FINAL PLAT FINAL PLAT OF RIFFEL'S ADDITION

Re: S/D 89-6 Final Plat of RIFFEL'S ADDITION

STAFF COMMENTS:

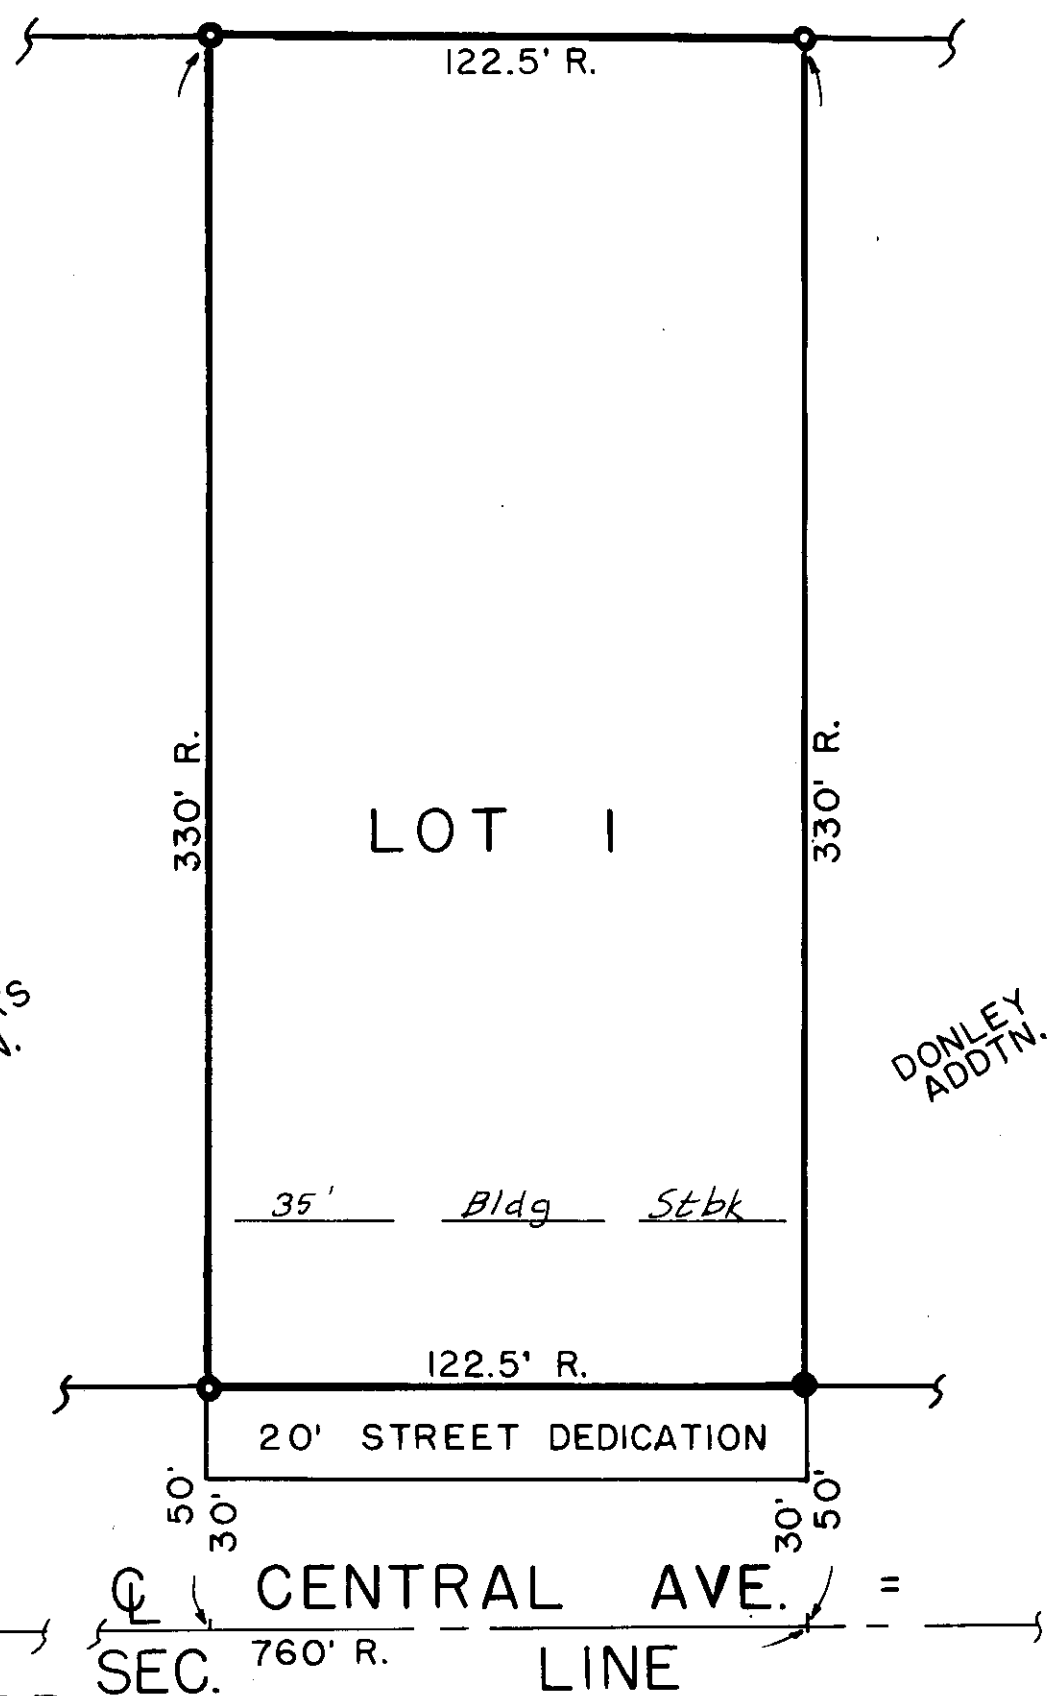
- A. The applicant shall guarantee the extension of sanitary sewer to serve the lots being platted. The final plat tracing shall also indicate a 5 x 20 foot stub easement along the south line of the plat for this extension of sewer.

- D. On the final plat tracing access control except for one opening shall be indicated on the face of the plat and referenced in the plat's text. The text shall indicate that this access control is being dedicated to the City with the one opening determined by the City Engineer.

- E. Prior to submitting the final plat tracing, the applicant shall submit a revised drainage plan to City Engineering.
- F. The final plat tracing shall indicate angles or bearings for the perimeter of this plat.

- G. On the final plat tracing, the City's signature block shall be amended by deleting Deputy from the City Clerk's signature.
- H. The applicant shall install or guarantee the installation of all utilities and facilities which are applicable and described in Article 8 of the MAPC Subdivision Regulations.

- I. The applicant's engineer is advised that the Register of Deeds is requiring the name(s) of the notary public, who acknowledges the signatures on this plat, to be printed beneath the notary's signature.
